CHRISTOPHER P. STATILE, P.A.

April 24, 2024

Regarding: **Block 2201, Lot 12, Borough of Hillsdale**
5 Strawberry Hill Road: Variance Application PZ-06-24
Marianne Illian, Applicant and Owner

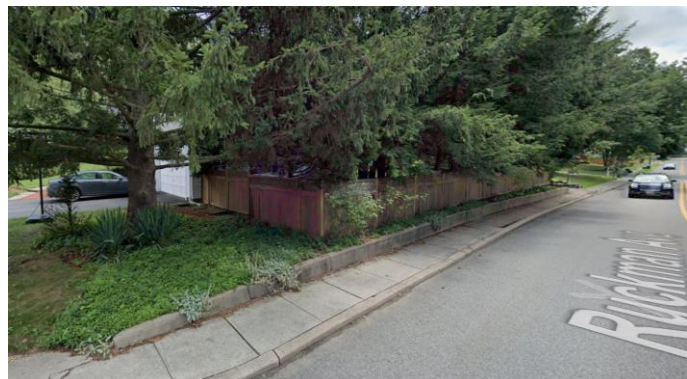
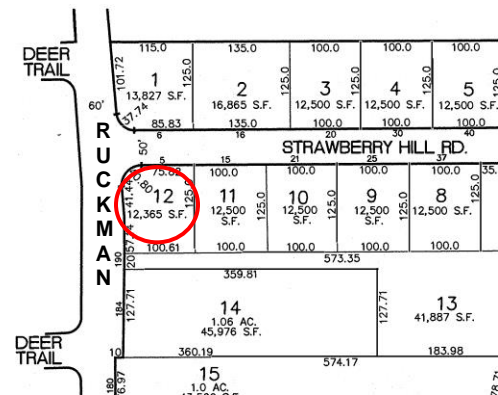
Note curb along back of sidewalk.
